PIC16F62X

PIC16F62X Rev. C Silicon/Data Sheet Errata

The PIC16F62X (Rev. C) parts you have received conform functionally to the Device Data Sheet (DS40300**C**), except for the anomalies described below.

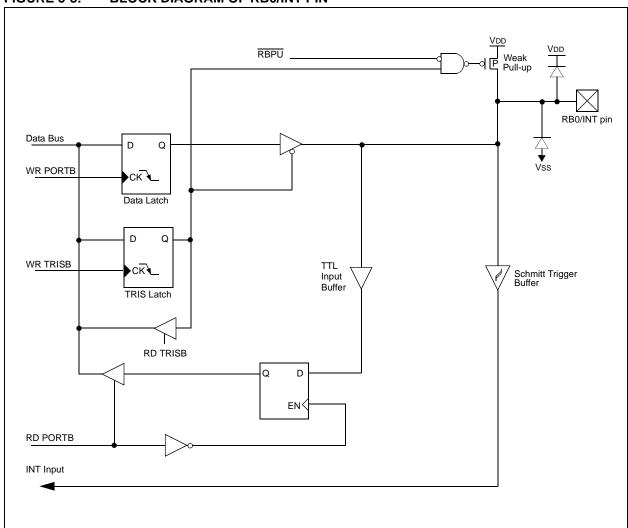
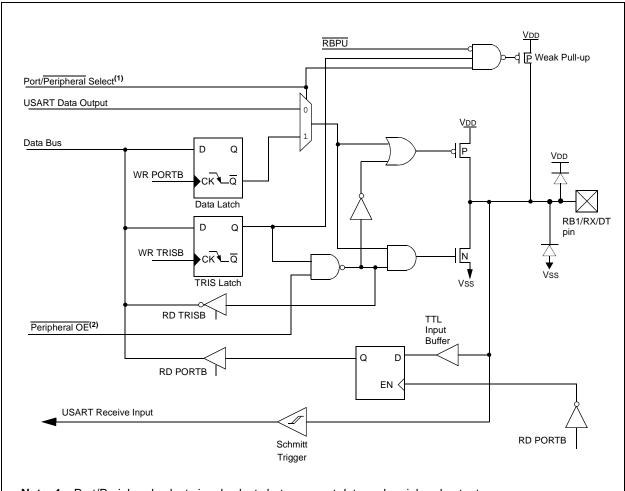
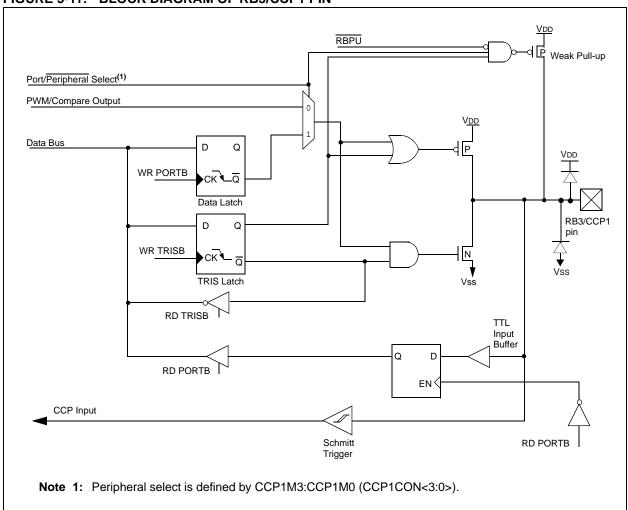
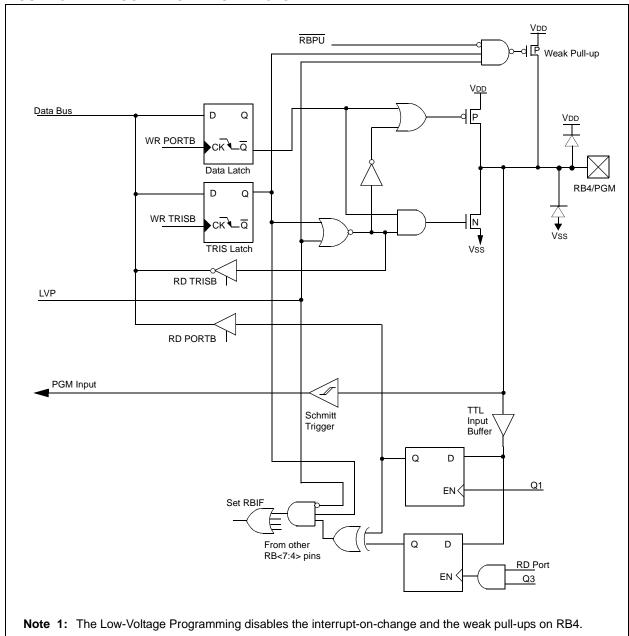
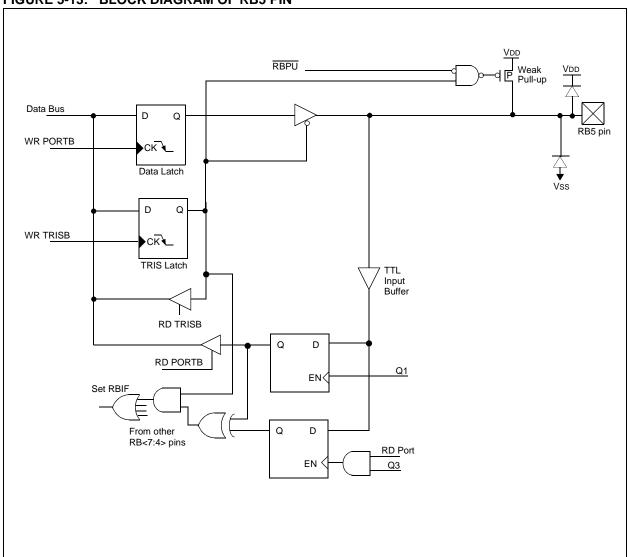
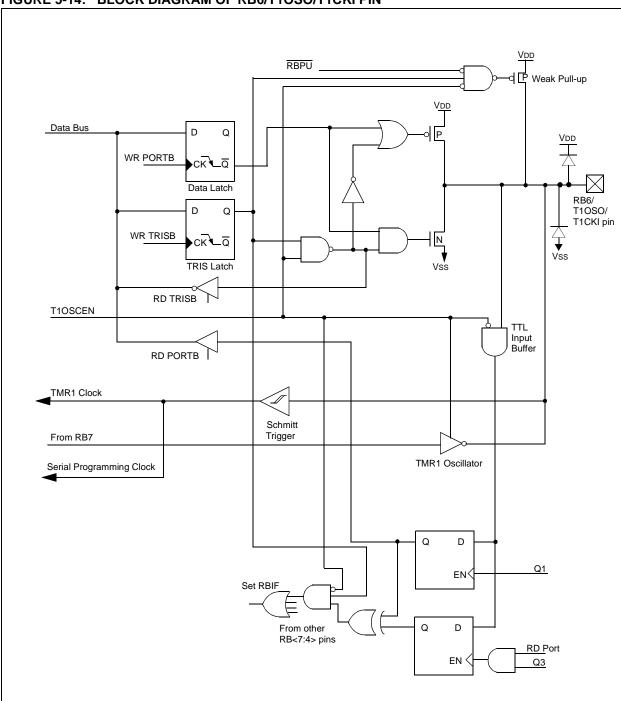
1. Module: I/O Ports

A read of the PORTB Data Direction Register (TRISB) returns the Data Direction state on the port pins themselves and not the contents of the TRISB register latch.

FIGURE 5-5: BLOCK DIAGRAM OF RA5/MCLR/VPP PIN

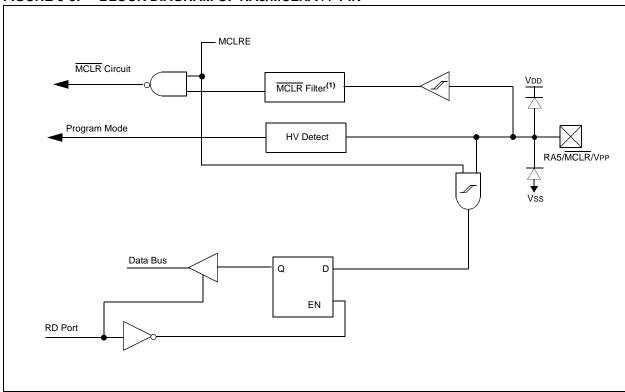
3. Module: I/O Ports (RA5/MCLR/VPP)

Figure 5-5, "Block Diagram of the RA5/MCLR/VPP Pin", is incorrect. The following diagram should be used instead.
